REMARKS

Version with Markings to Show Changes Made

FIG. 4

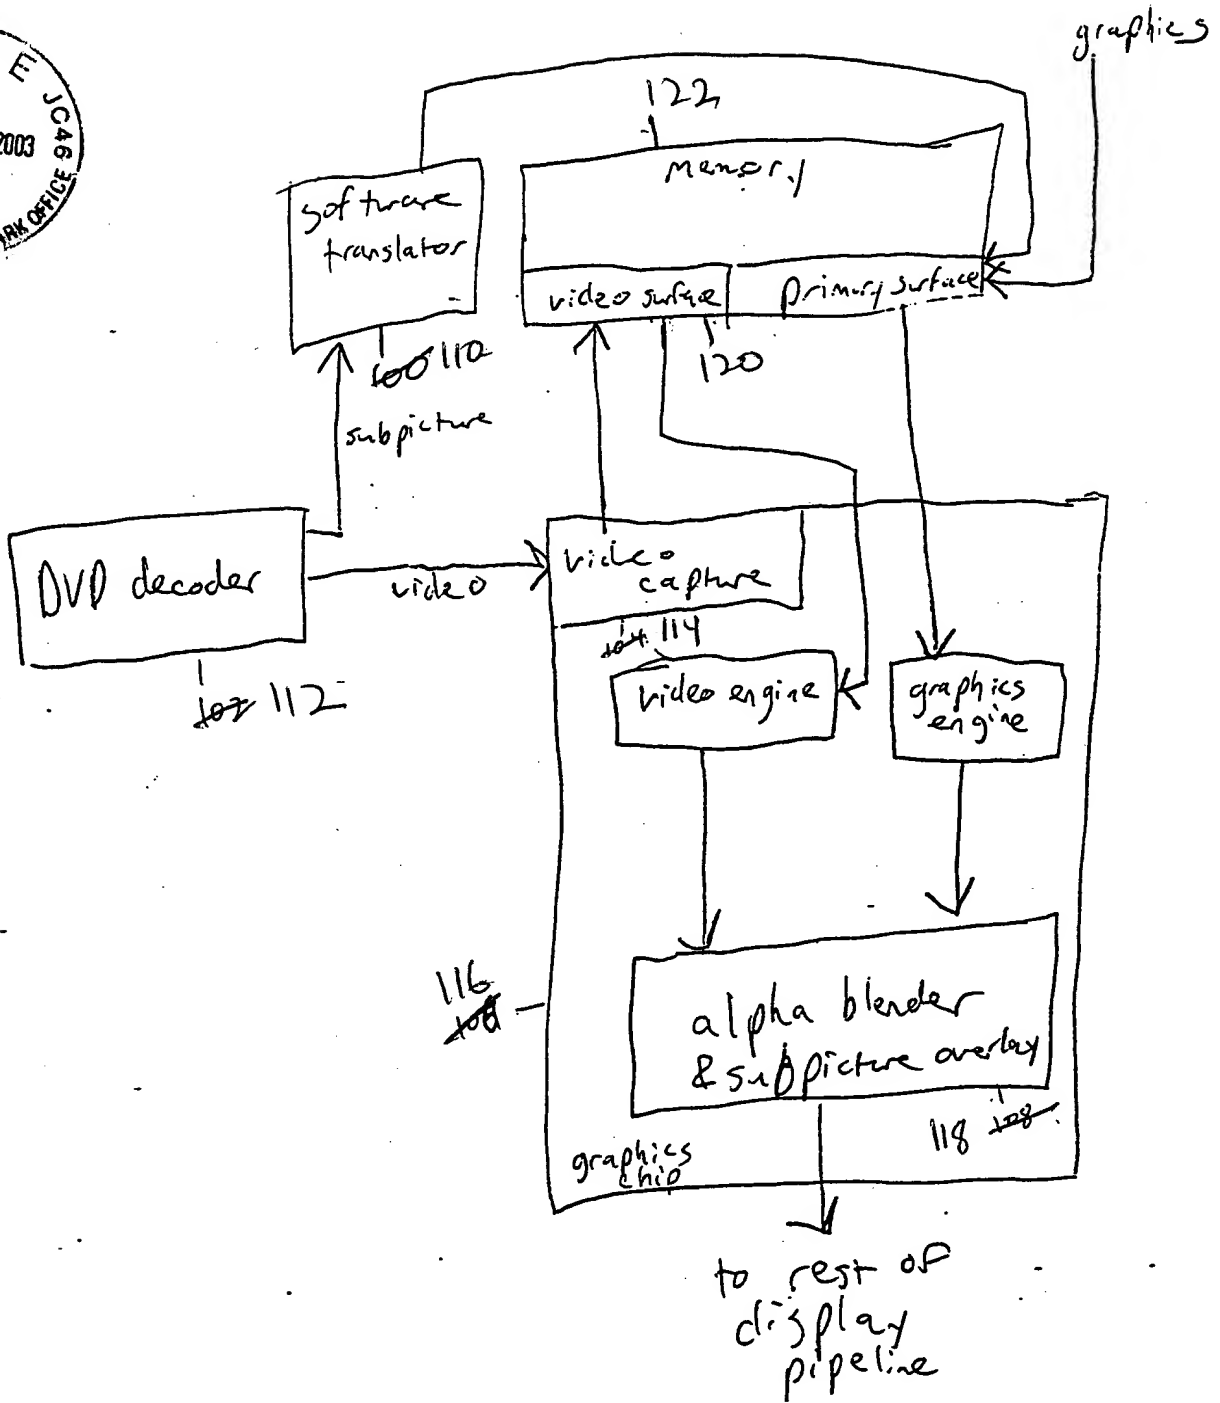
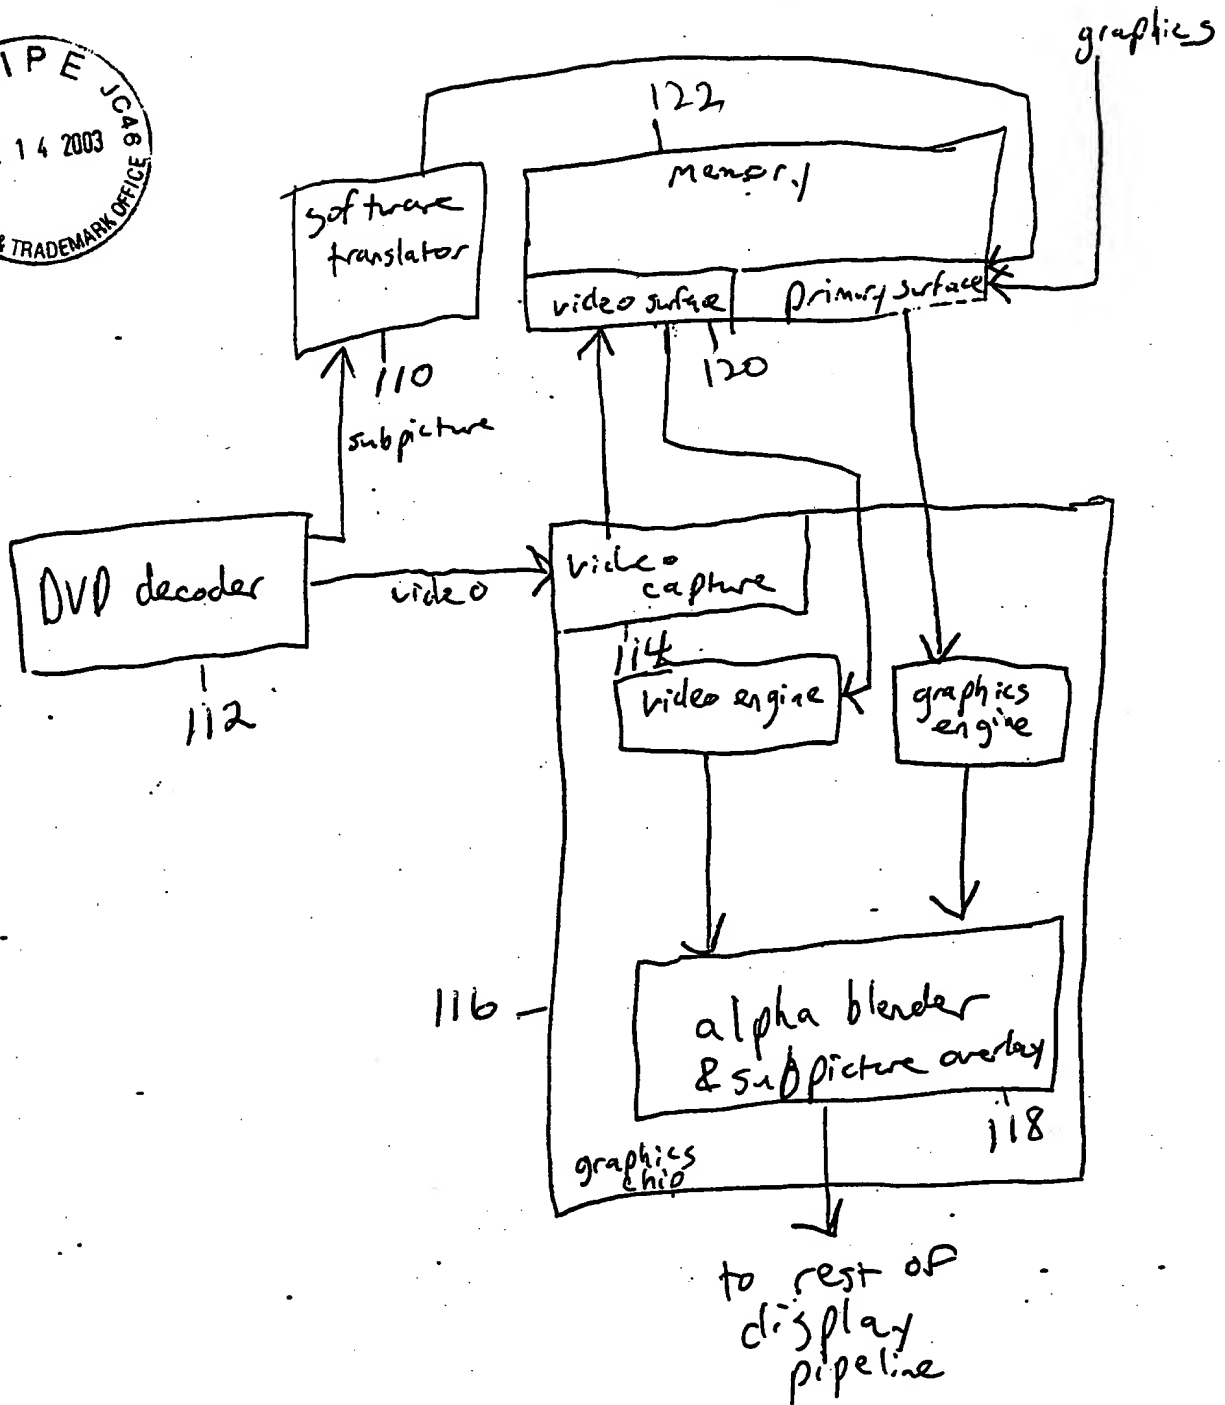
FIG. 4 is a block diagram illustrating the organization of a presently preferred embodiment of the present invention. A software translator [100] 110 receives subpicture information from a software DVD decoder [102] 112, while video information is sent to video surface [110] 120 in memory [112] 122. DVD decoder [102] 112 would likely have been designed to combine separate video and subpicture streams since DVDs are encoded with separate streams, so separating out or requesting that the separate streams not be combined in the first place should not present a problem. To the extent that it does, however, an additional module may have to be placed after the DVD decoder [102] 112 to separate out the subpicture and video streams. The present invention also assumes that the subpicture information received by the software translator [100] 110 is in the standard 4:4 format. To the extent that it is not, it must be translated into that format.

The graphics chip [106] 116 is also modified to include an alpha blender and subpicture overlay block [108] 118 rather than simply an alpha blender. This is because the key potentially encoded into the stream by the software translator [100] 110 needs to be encoded in some fashion. With a software DVD decoder [102] 112, video capture module [104] 114 may not have to be used. The details of this operation will be described later in this document.
